Additional clarification response to Planning Policy H2.

Job Title
DoubleTree West End Hotel, Southampton
Row, London, WC1B 4BH

Phase 3 Preliminary Proposals

Drawing Title
H2 Policy Plan - Response

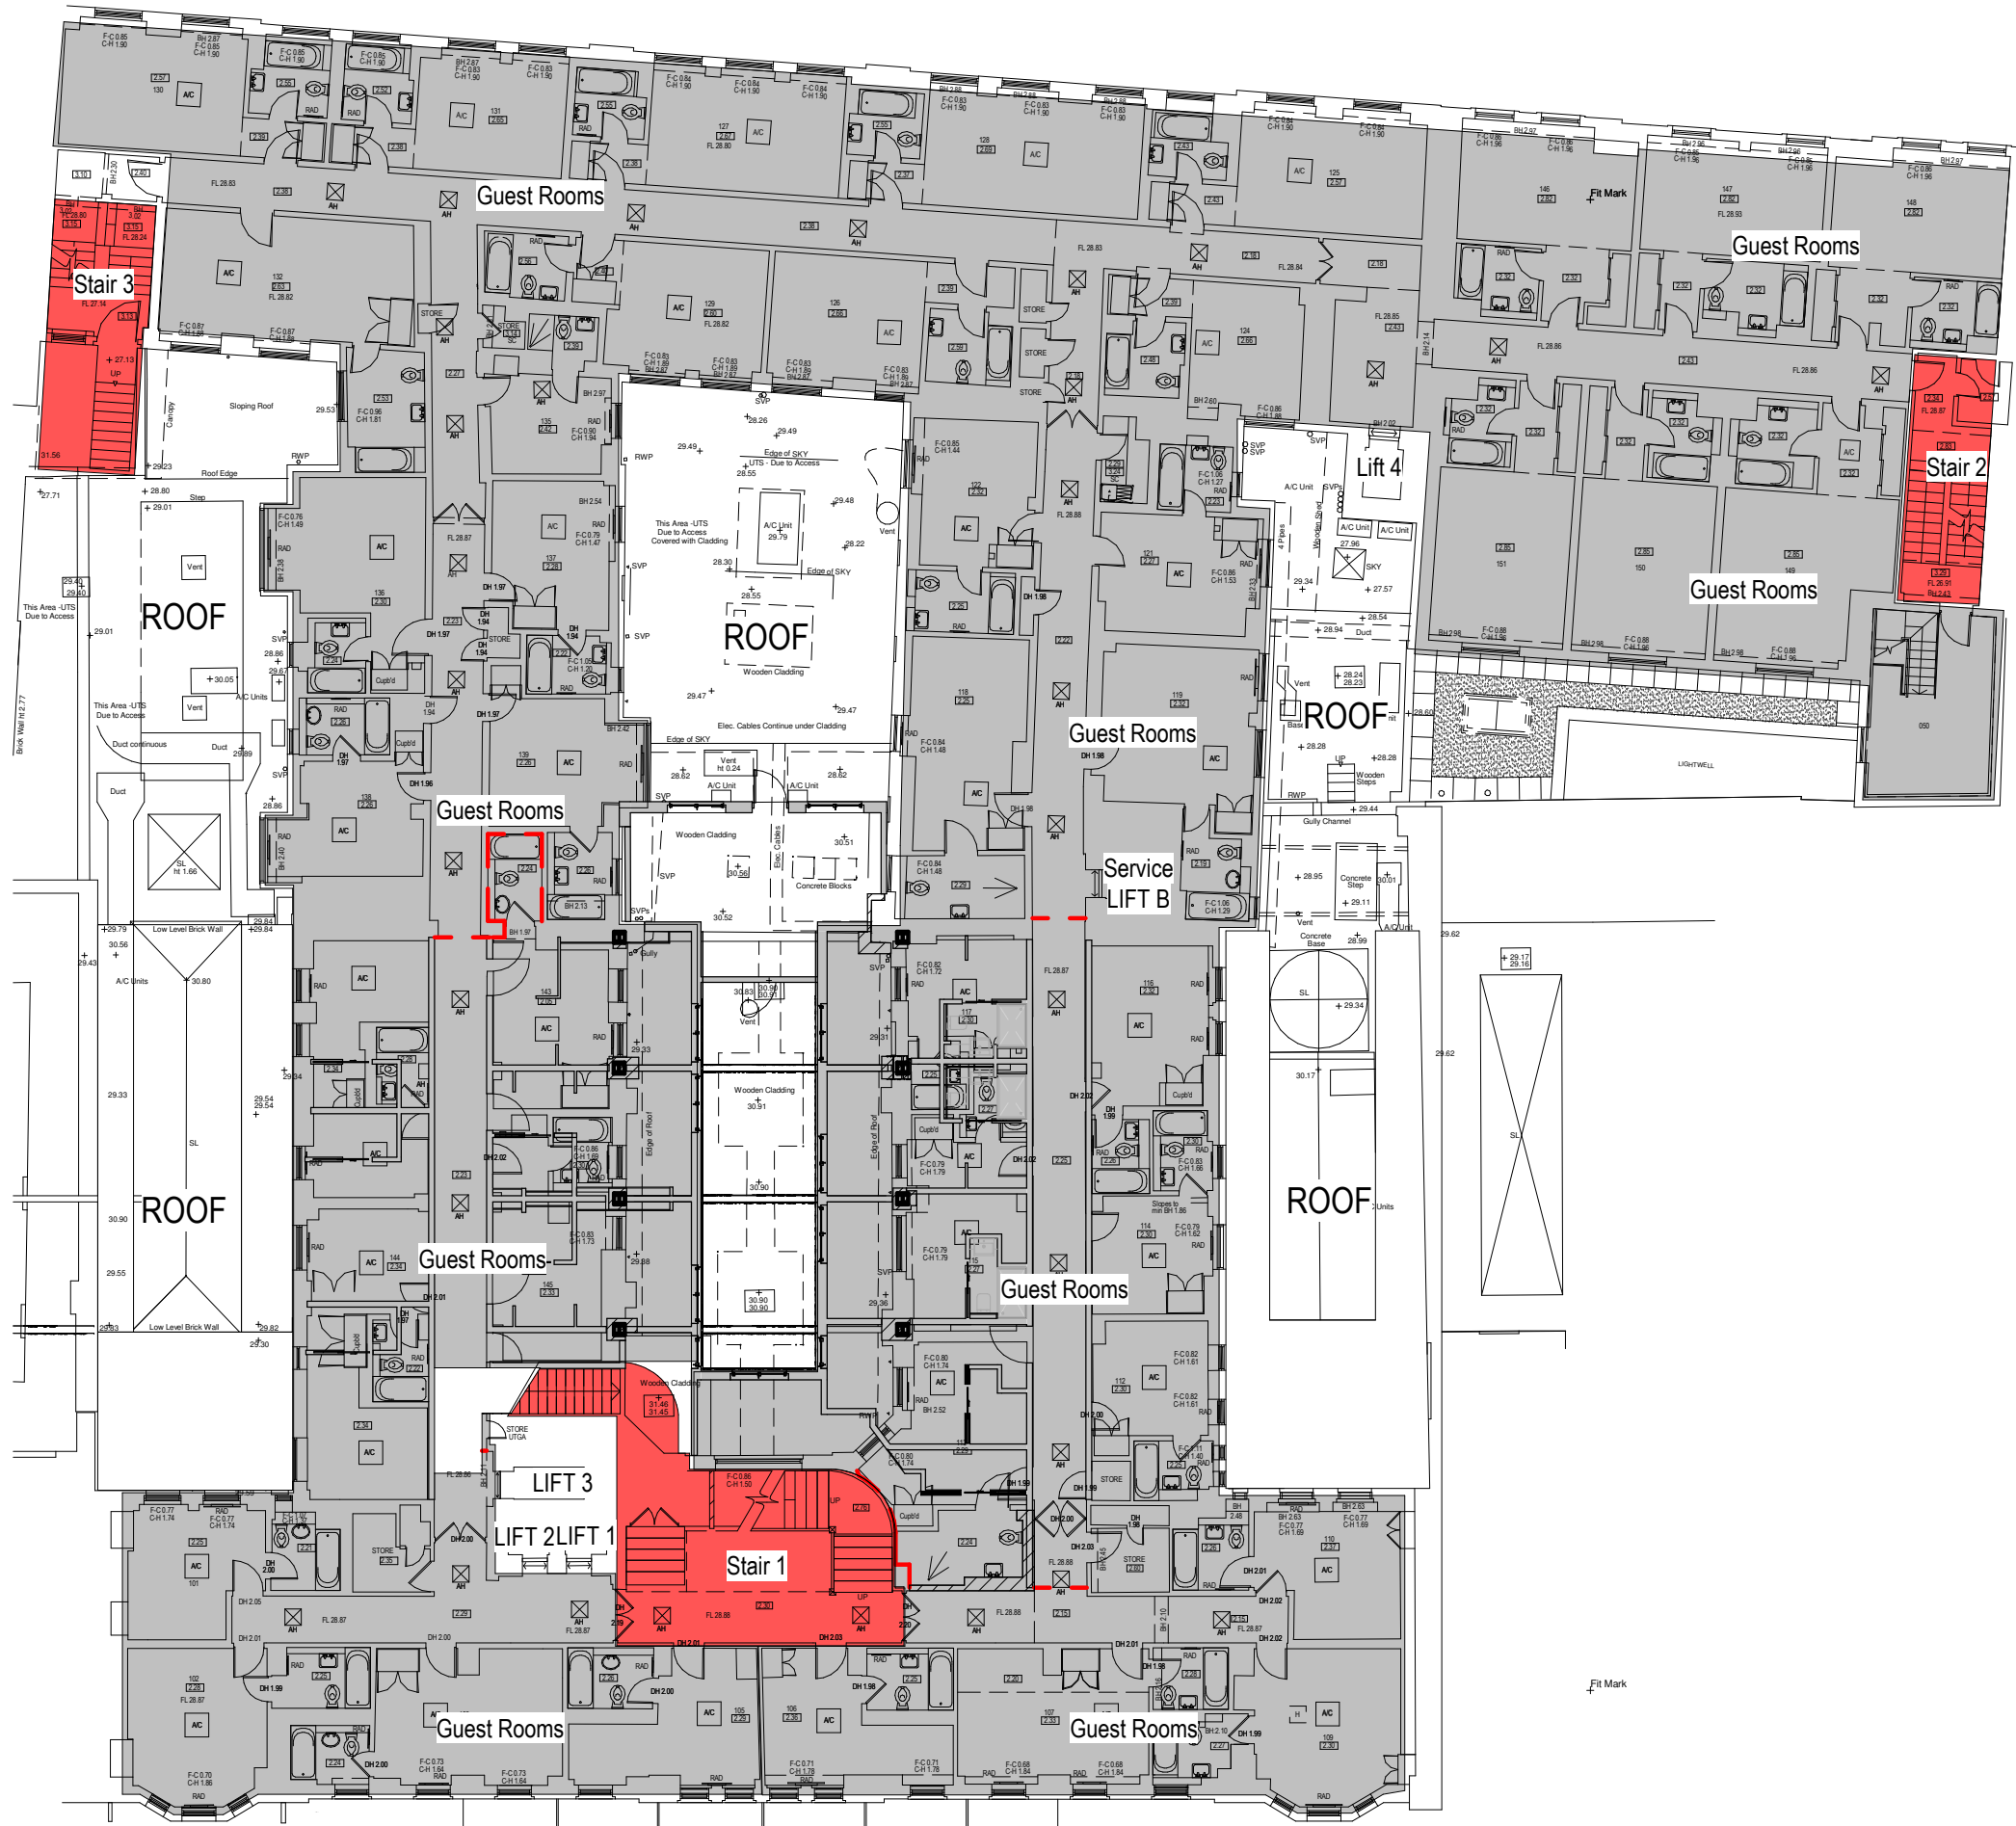
1. **Possibility of sharing a stair core to the rear of Old Gloucester Street. Are the 2nr stair cores required?**

2. **Possibility of reusing one of the existing lifts for residential use only.**

Response. To comply with the requirements to provided safe means of escape in the event of Fire, the hotel requires a minimum of 3nr protected stairs. The fire strategy is based upon the industry standard assumption that one of these may be 'out of action' during an evacuation and so occupants have a choice of 2 alternative escape routes. As such it is not feasible to provide one of these stairs as a dedicated access for residential use, as this may result in only one means of escape being available to the Hotel. The alternative of sharing a stair is not feasible due to security issues, as the stairs provide unrestricted access to both Guest and Back of House staff areas. Any additional security measures that would need to be installed could compromise the free use of these stairs in an evacuation event and the operational functionality of the hotel.

Response, during the design process the client engaged a traffic analysis evaluation of the existing lift provision (Aston VTC) , with a view to the possibility of removing one of the 3nr existing guest lifts at the main entrance. This was based upon the number of rooms proposed to be accessed in the hotel, the hotel occupancy and average number of people in each room. The assessment concluded that; '...based on the information you have provided we have carried out a traffic analysis using simulation software which compares the performance of a two lift Duplex system against a three lift Triplex system. The results are indicative but confirm that there will be significant increases in Passenger Waiting Time (seconds) and Passenger Time to Destination (seconds) by removing Passenger Lift 3.' 'The calculations are also based on the most efficient system in that all three lifts in the Triplex Group scenario are interconnected and therefore all three lifts share the same workload.' 'Further to your request our initial response is that removing Reception Lift 3 and running two lifts will not provide enough handling capacity for the hotel.'

There is an additional guest lift to the rear of the hotel, Lift 4 which is needed to provide access to floors above, due to a difference in levels within the hotel between the front and back, these rear rooms are not accessible from Lifts 1, 2 & 3.

There are an number of dedicated Service lifts A,B & C which cannot be used for other purposes without impacting the functionality of the hotel.
